## CITY OF ALBUQUERQUE

RE: Silver Star Auto Haus

Engineer's Stamp Date: 3/19/2018 Hydrology File: C17D014A1

Based on the information provided in the submittal received on 3/20/2018 the above-referenced Grading and Drainage Plan is approved for Site Plan for Building Permit. The following comments must be addressed prior to approval for building permit and SO-19 permit.

# EAST PROPERTY LINE SECTION (F

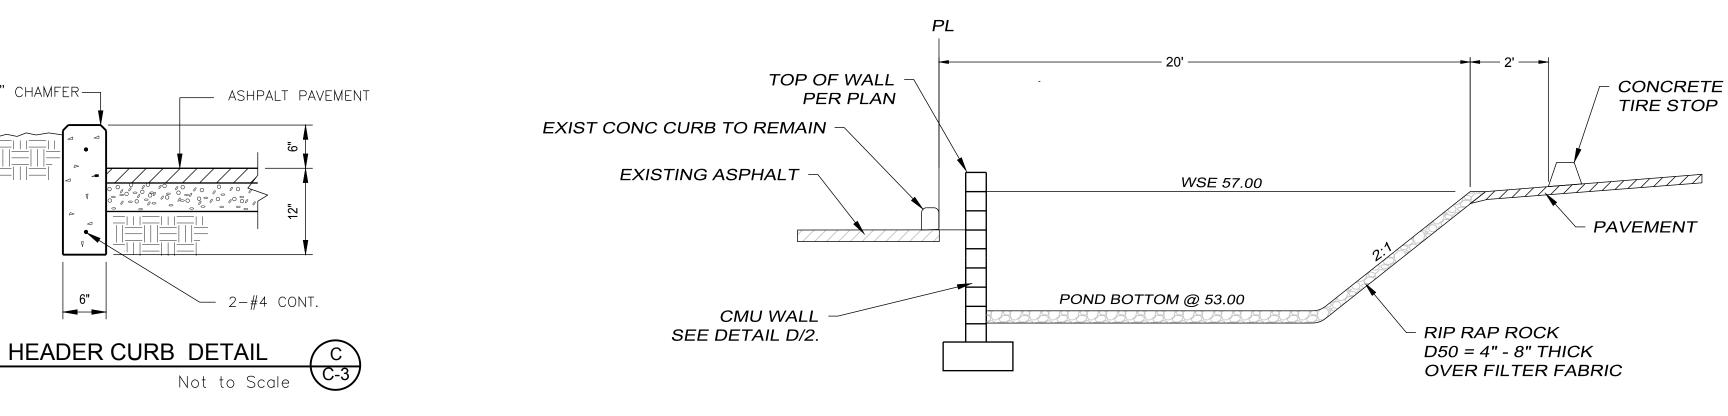
- 2. Add the words "see Notice to Contractor on sheet C-3" to keynote 28 on sheet C-2, and check the "SO-19 Approval" line on the DTIS.
- 3. Please consider moving the retaining walls away from the property lines to keep the footer out of the soil friction plain. Add a note on the plan view stating that "no encroachment is allowed into the neighbor's property without written permission and any damages to the neighbor's property must be repaired". Consider adding a requirement for piling and/or shoring of the taller cuts.
